C2PC Request Letter

Class II permissive change for **FCC ID: 2BH7FWR3602BE**

(Original Grant Date: 06/09/2025)

Applicant: TP-Link Systems Inc.

FEM (Previous)	FEM (New)
Model	KCT8578HT	QPF4557
Picture

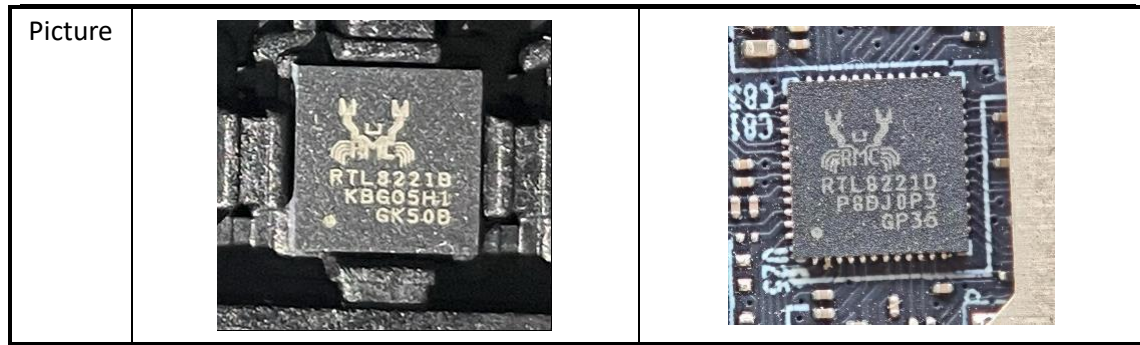
- 1. The 5GHz FEM (Front-end Modules) ICs have been changed. And the new FEM IC is Pin-to-Pin compatible with the previous one.**

The PHY chip will connect to the main chip (RF). In this modification, the Wi-Fi 2.4G/5G RF routing remains unchanged or unadjusted, and the FEM parameters are also the same.
